Following additional parts are required to add glassfiller (029603-004) to standard P8ACY (503961). Please note that it is not possible to remove the bubbler valve from the cooler – the bubbler acts as a vent when pressure builds up in the tank as a result of ice formation.

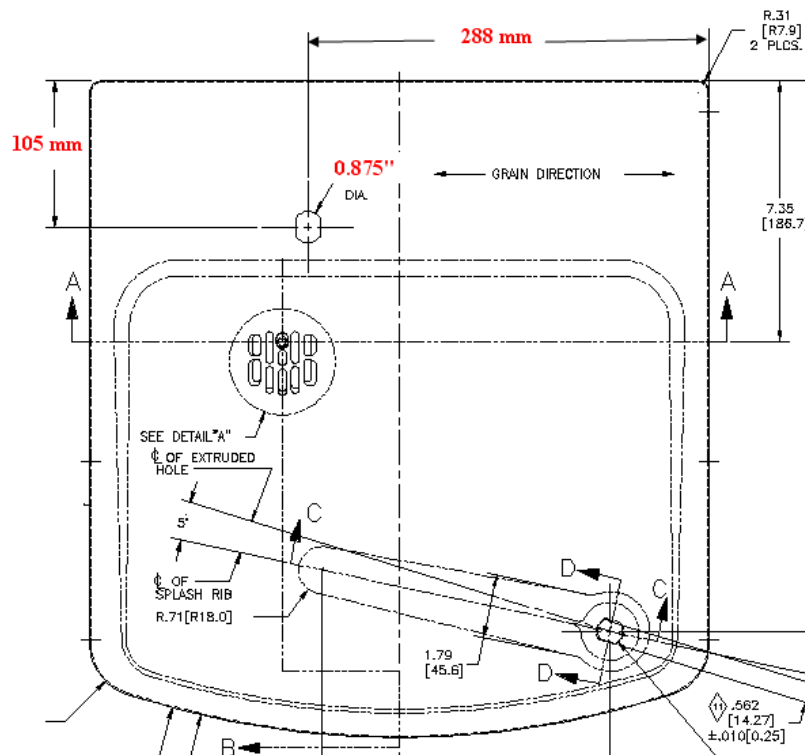
Installation requires a 7/8" (0.875") diameter hole to be drilled in the top in the position shown below.

This installation needs to be carried out in the factory – most customers will not be capable of doing this job
